30-041-10177

O'Neill State SWD

## SUNDRY NOTICES AND REPORTS ON WELLS

**Proposed to Plug & Abandon as follows:**

**Proposed P&A Configuration**  
 Last Update: Apr'13

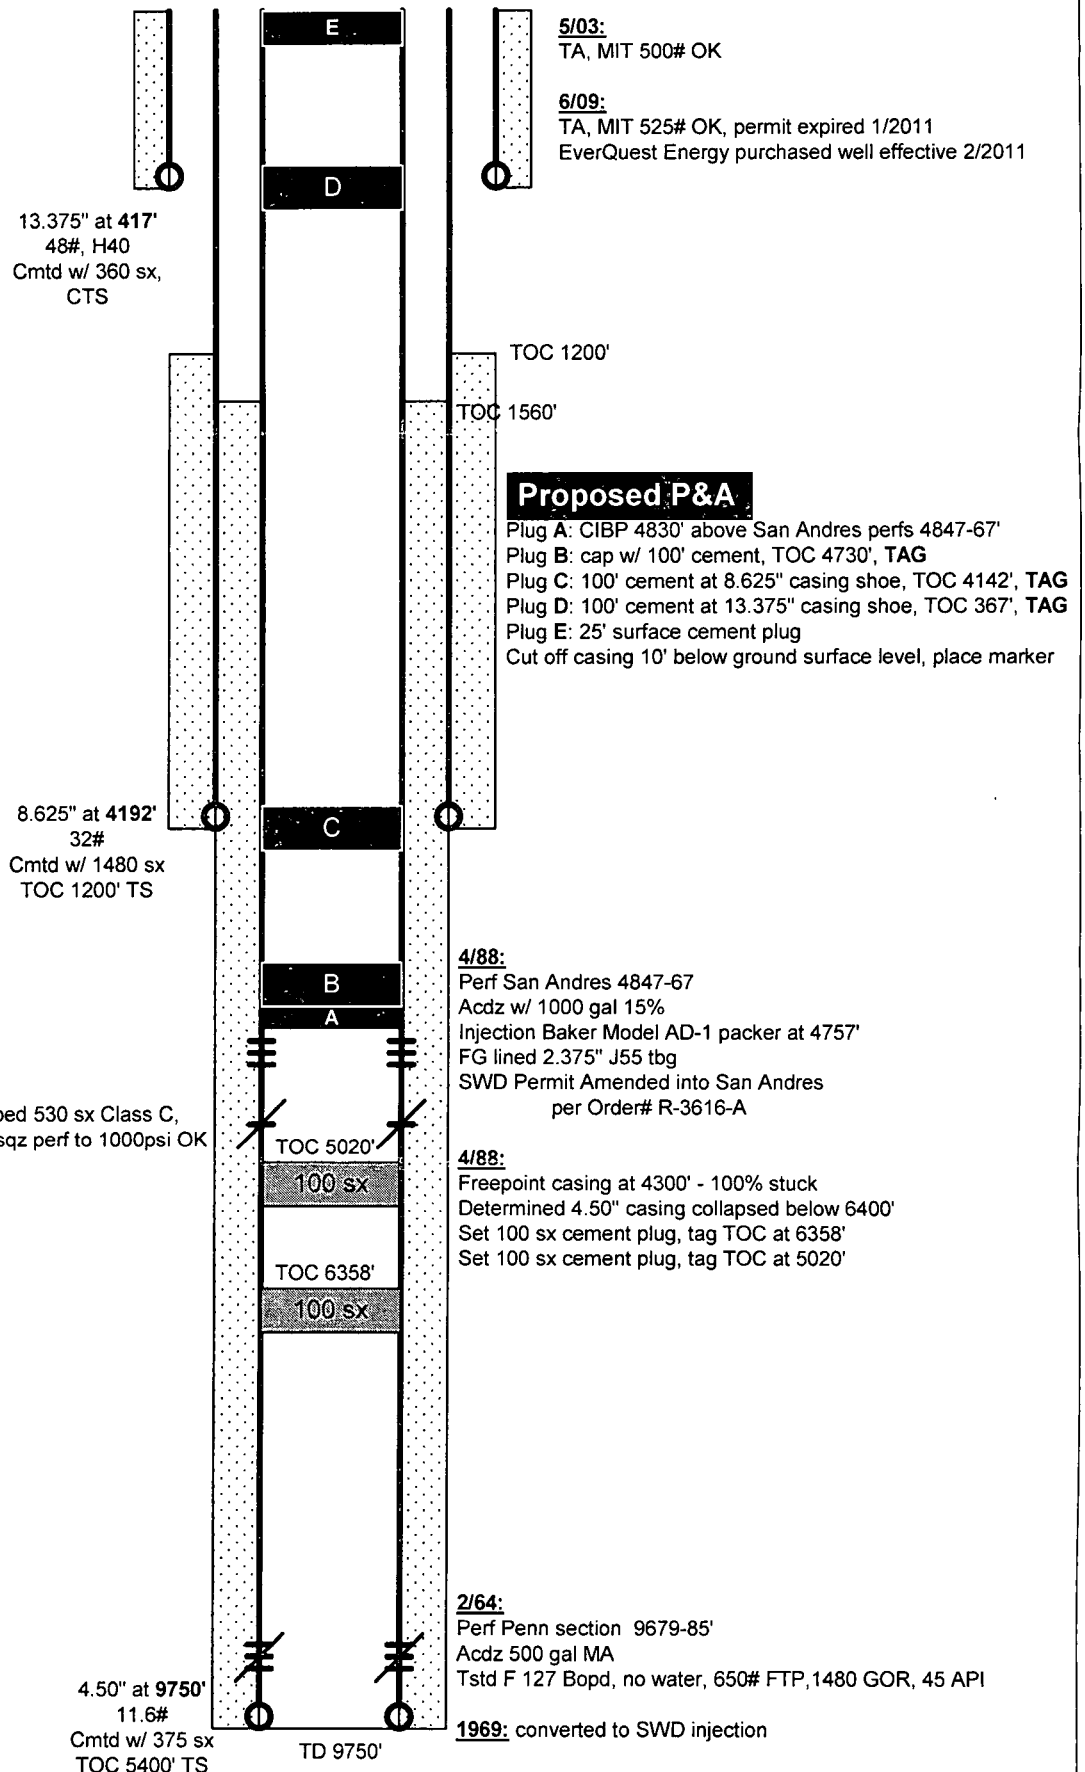
Isolate SWD perfs 4847-67' perfs w/ CIBP at 4830' capped with 100' cement to 4730', tag plug.

Overlap 8.625" casing shoe with 100' cement w/ TOC at 4142', tag plug. SPOT CMT @ 4242'

Overlap 13.375" casing shoe with 100' cement w/ TOC at 367', tag plug. PERF &amp; SQZ 25 SXS

Place 25' cement plug at surface. - PERF &amp; CIRC CMT 60' TO SURF. @ 467'

Cut-off casing 10' below ground level. Place P&amp;A marker.

Note: casing will be filled with 9.5ppg brine+12.5ppb gel per OCD Rules

Oil Conservation Division - Hobbs office: Must be Notified  
24 hours prior to the beginning of Plugging Operations begin.
